RESPONSE TO RAI #1 GAS COLLECTION AND CONTROL SYSTEM CONSTRUCTION CERTIFICATION

SOUTHEAST COUNTY LANDFILL HILLSBOROUGH COUNTY, FLORIDA

Subject: Response to Request for Additional Information (RAI) No. 1
Gas Collection and Control System Construction Certification
Southeast County Landfill, Hillsborough County, Florida
Permit No. 35435-016-SC/08
WACS No. SWD/29/41193

6 of 30

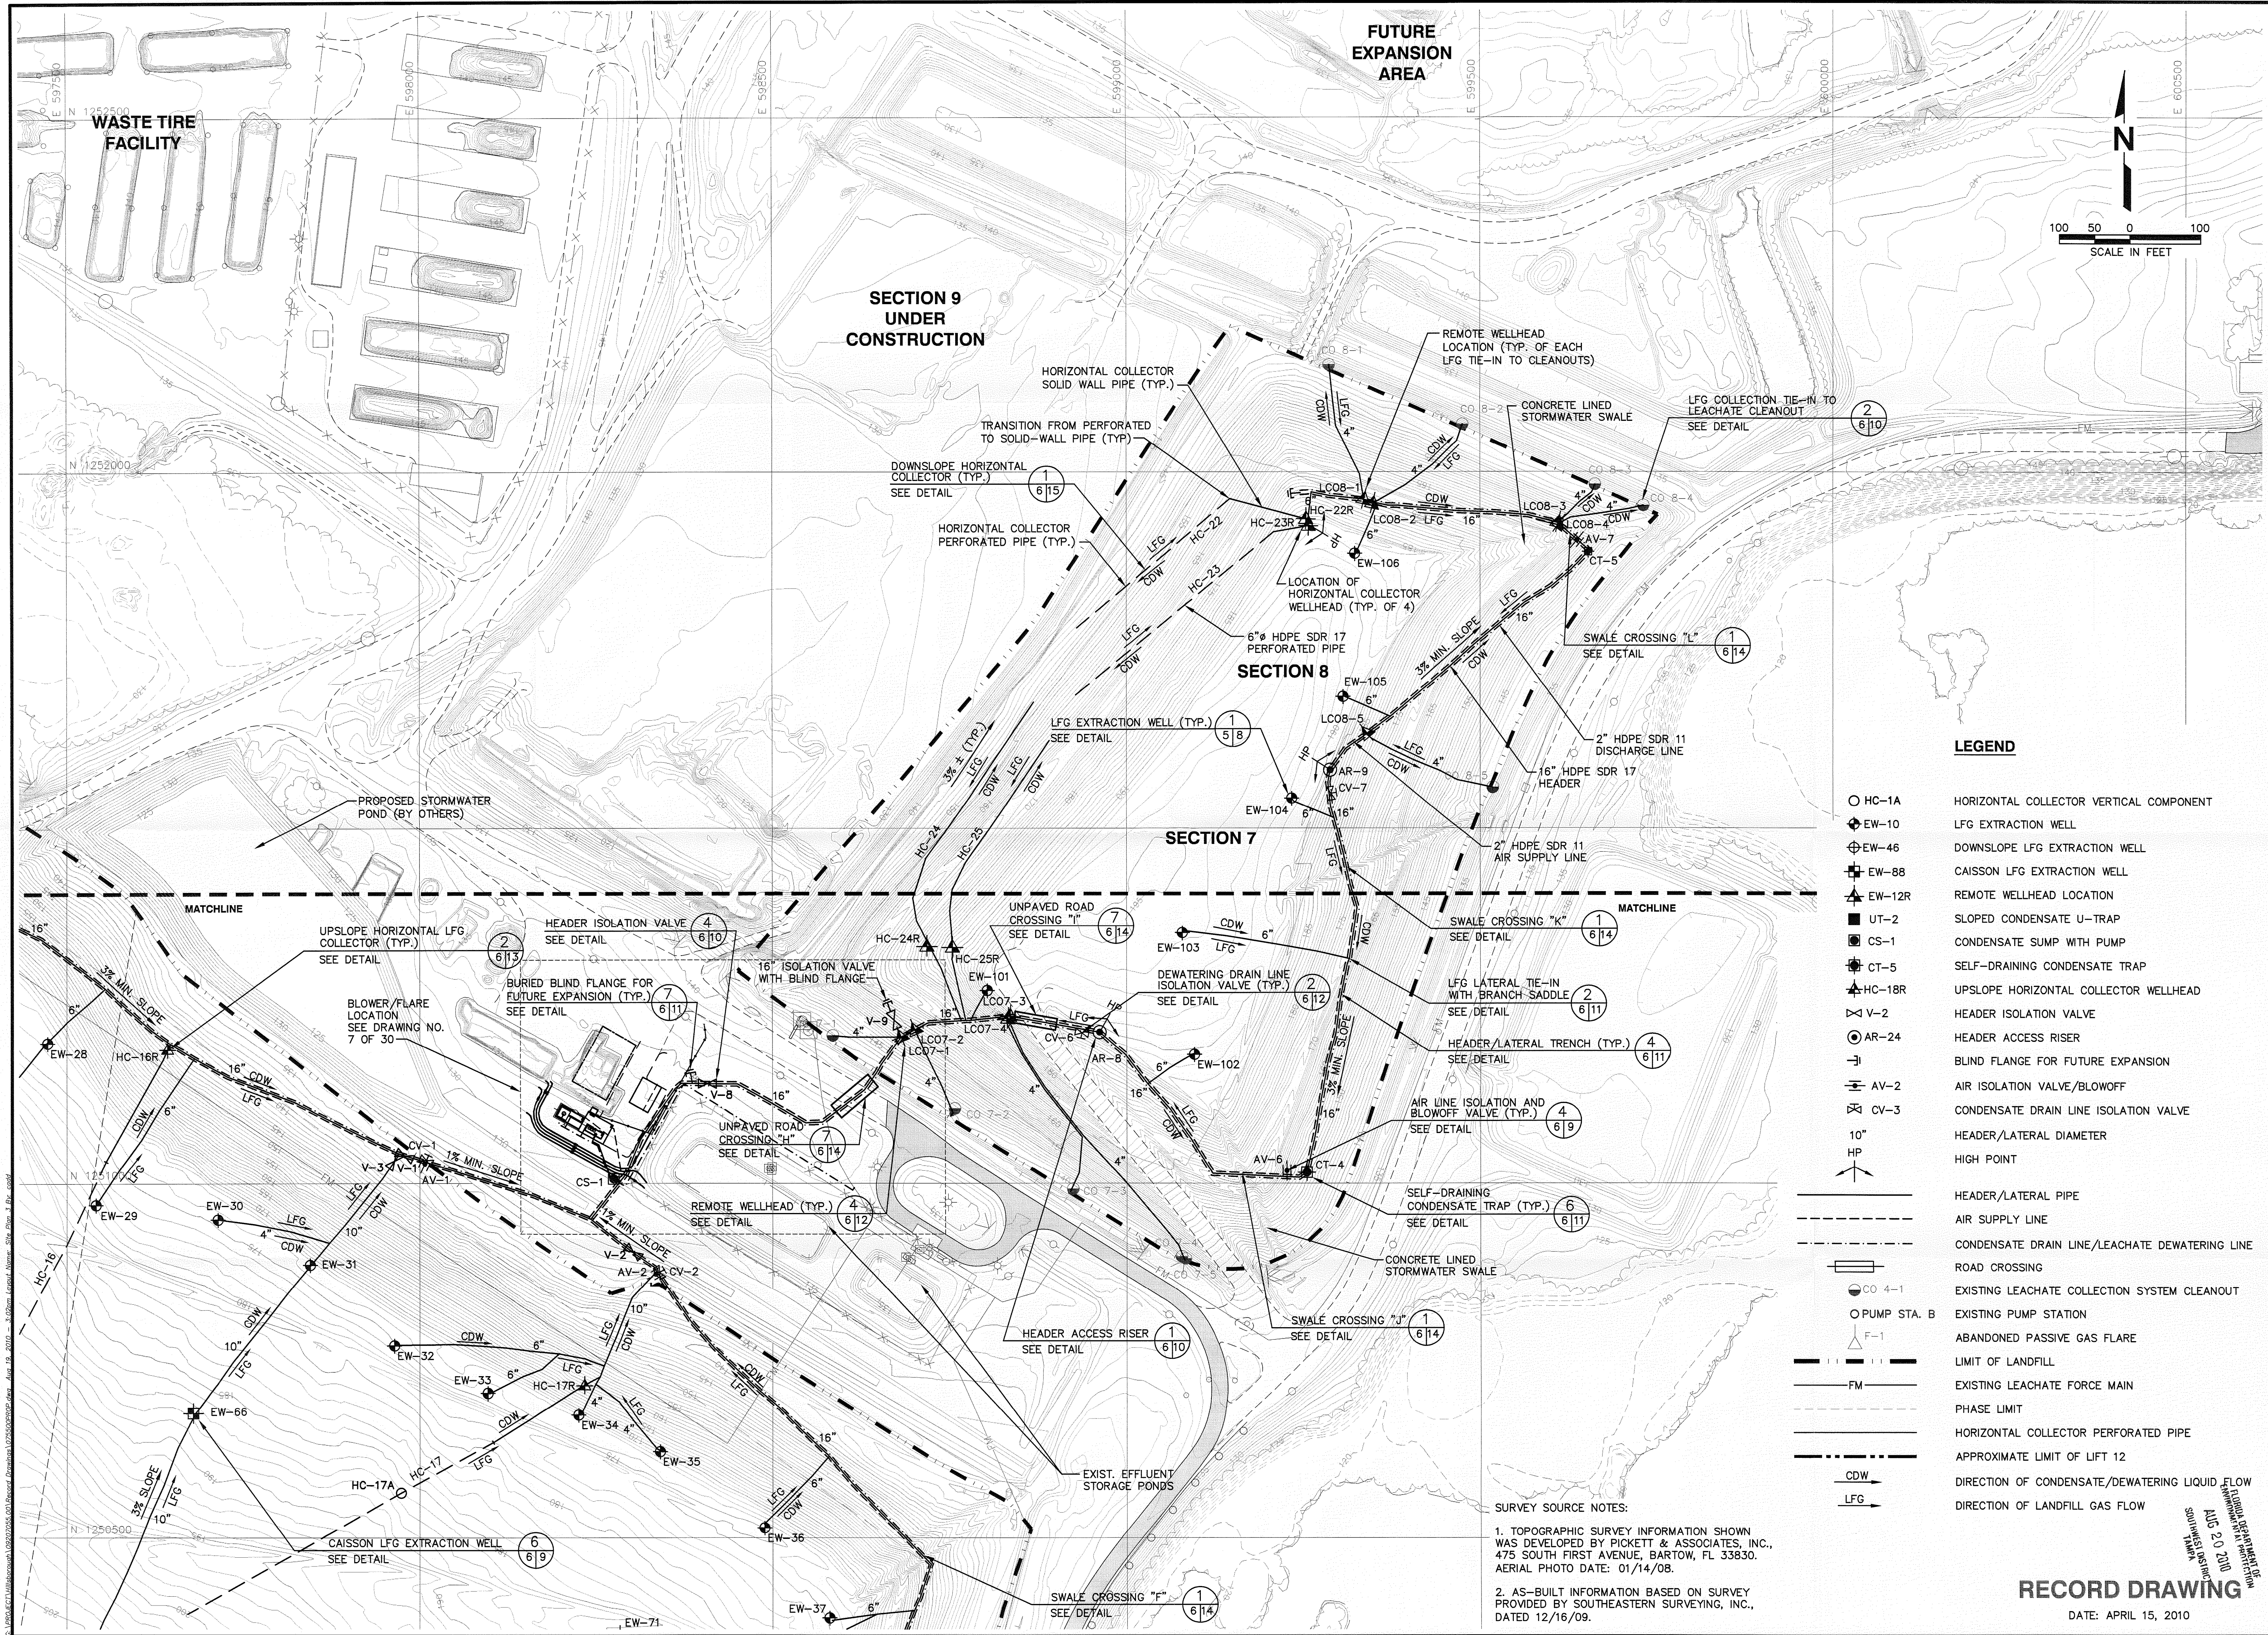
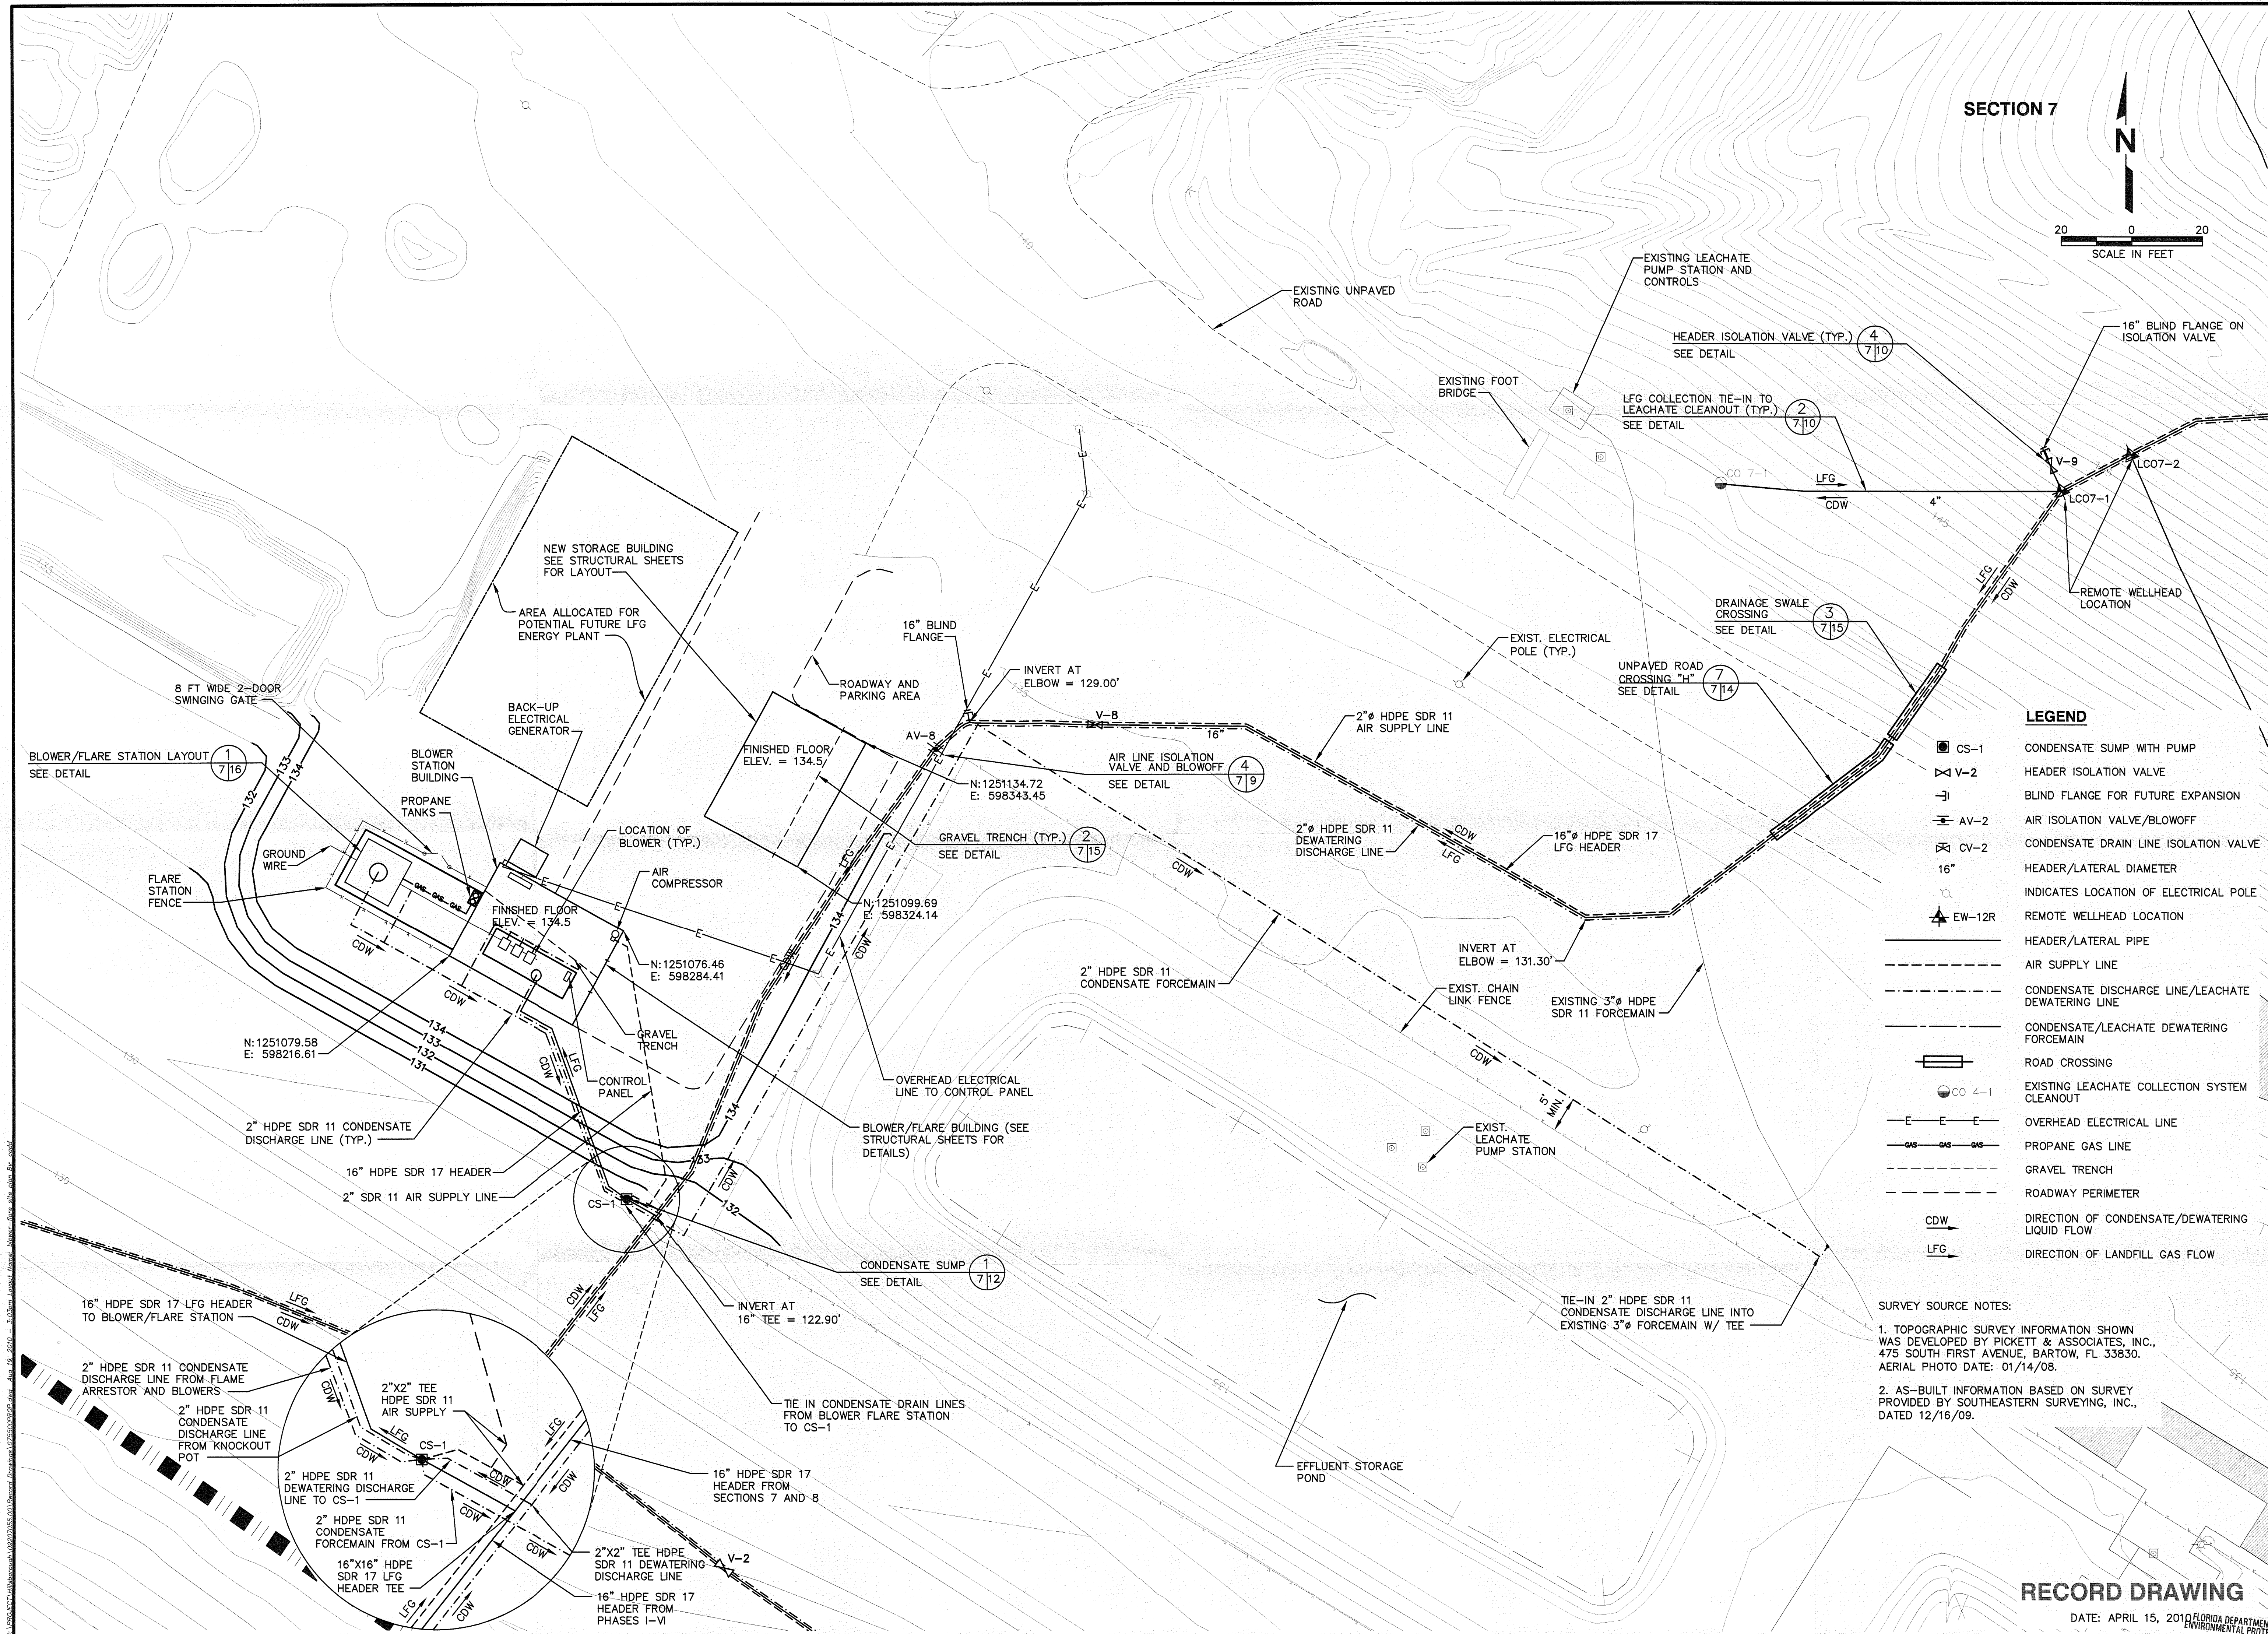
8. **Sheet 6 of 30: Please explain the change in location of CV-6 (See Comment #1.a).**

Response: Attachment 2 of this response contains a revised Report of Construction that further describes the reasoning behind the relocation of all condensate valves CV-1 through CV-7 from various locations on the sideslopes to the nearest highpoint adjacent to a header access riser.

SECTION 7

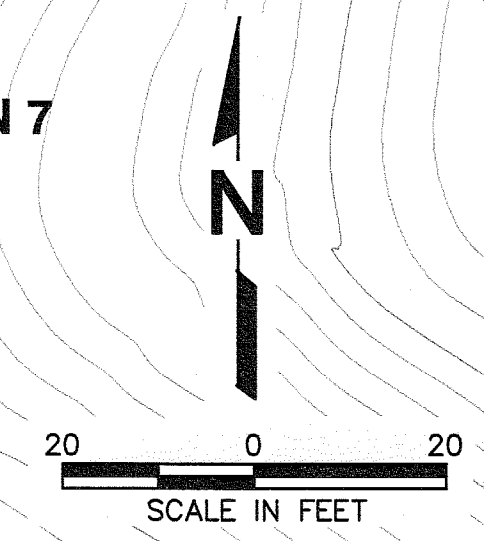
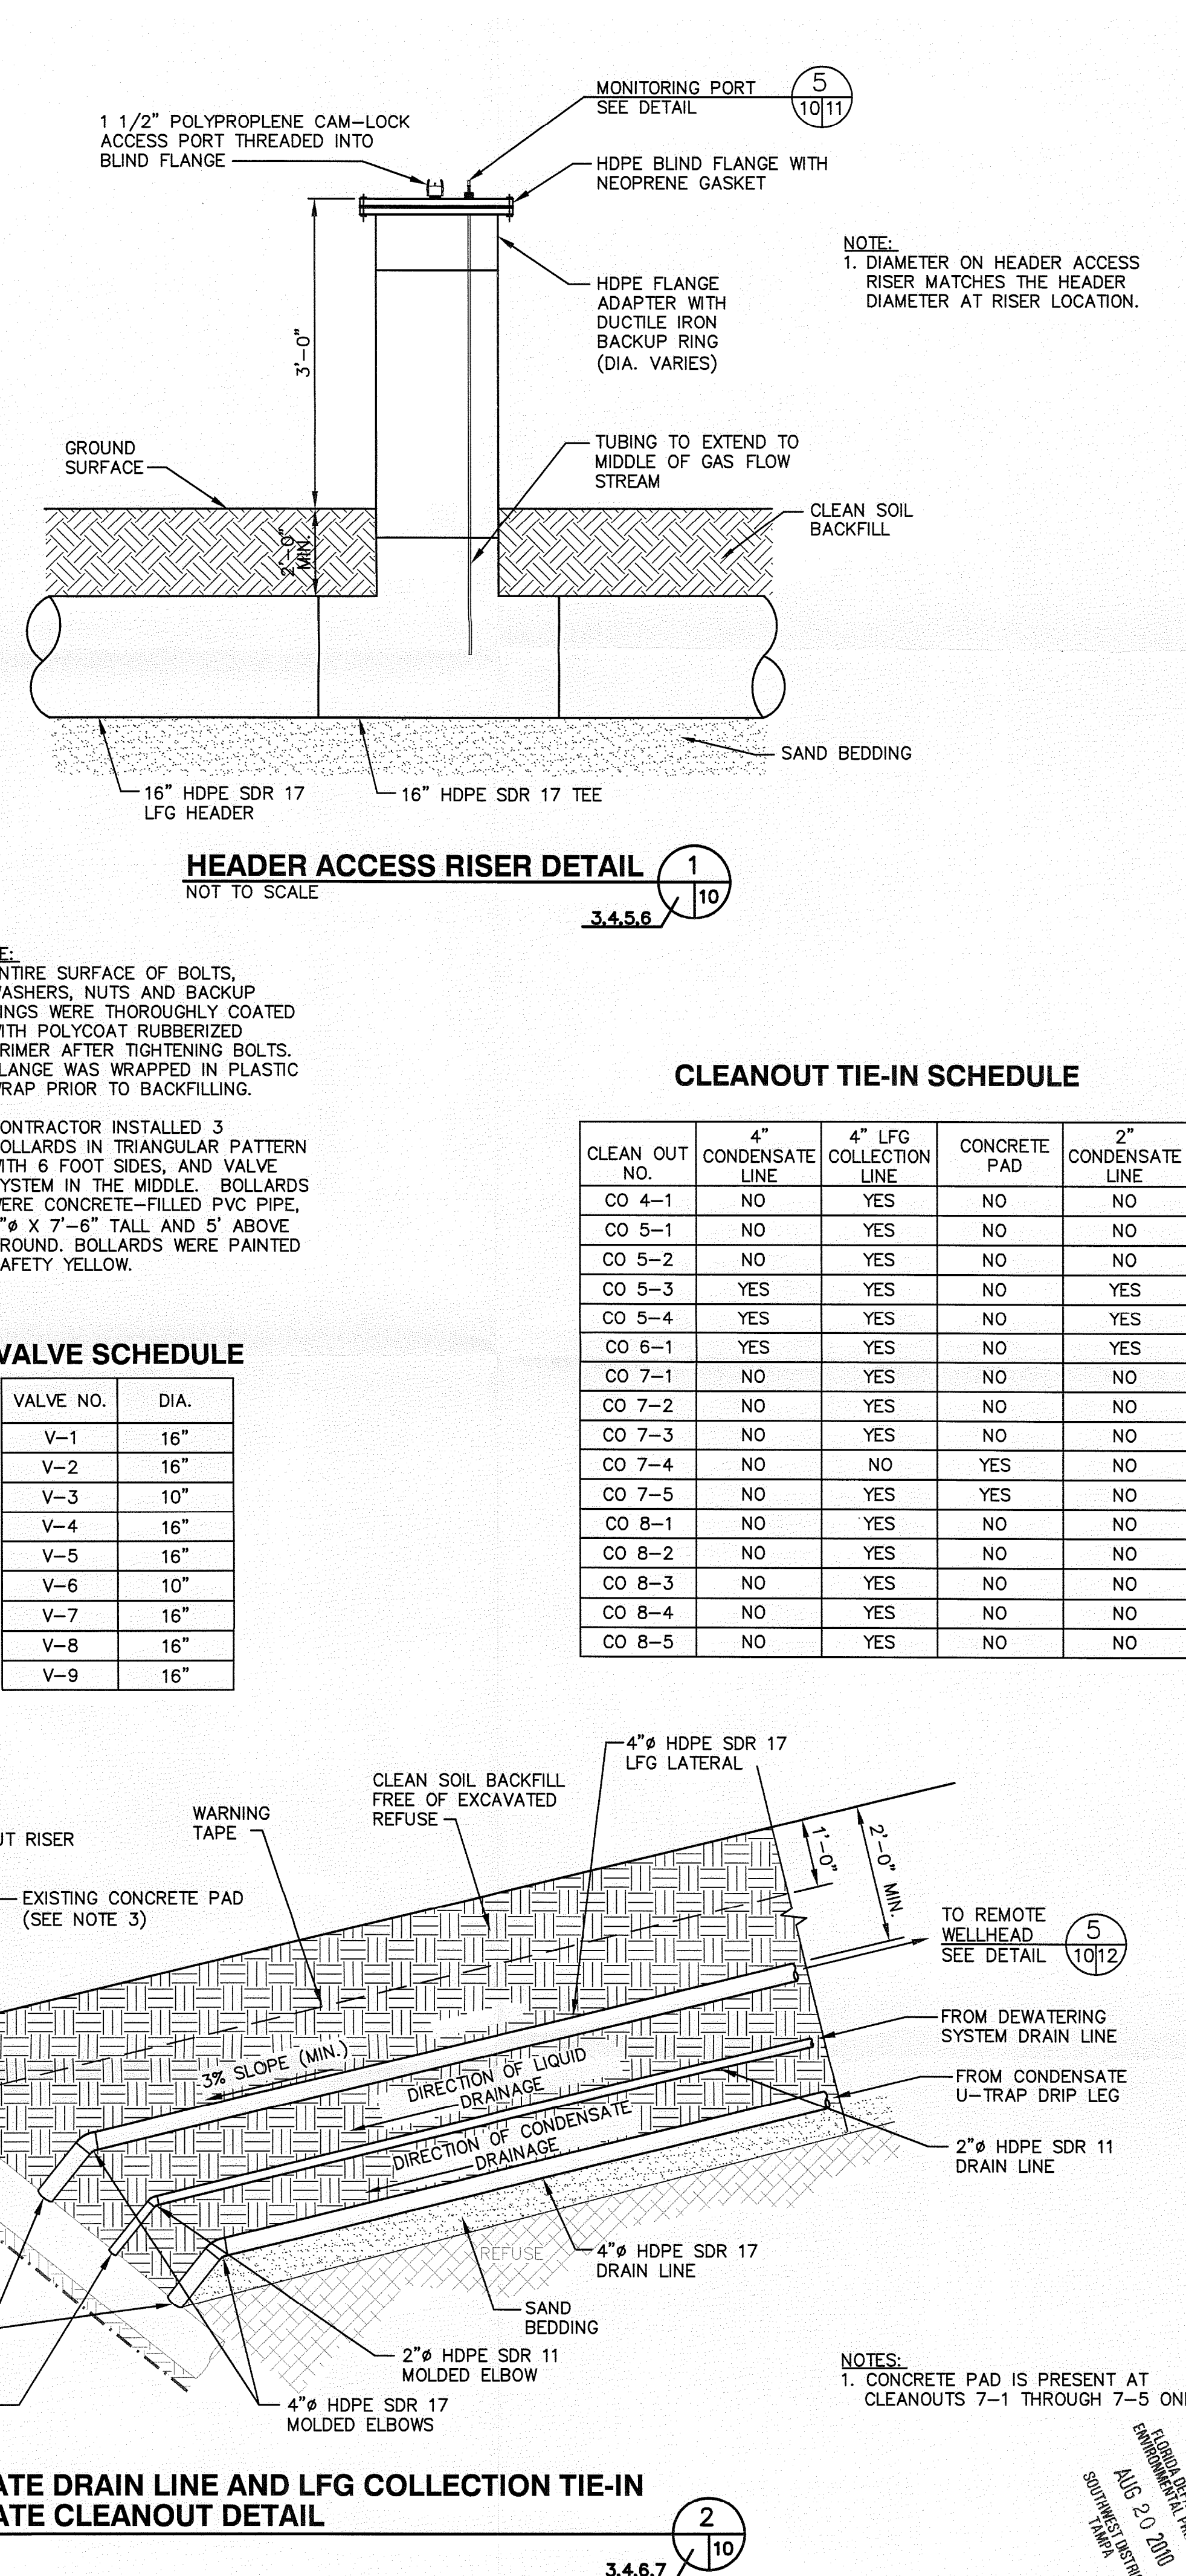
9. **Sheet 7 of 30: Please explain the change in configuration around CS-1 and the elimination of AV-8 (See Comment #1.a).**

Response: Attachment 2 of this response contains a revised Report of Construction that contains further description of the reasoning behind the relocation of AV-8, which allowed for the isolation of the air system on Section 7 & 8. The remainder of the items entering and exiting CS-1 have not changed from the approved plans.
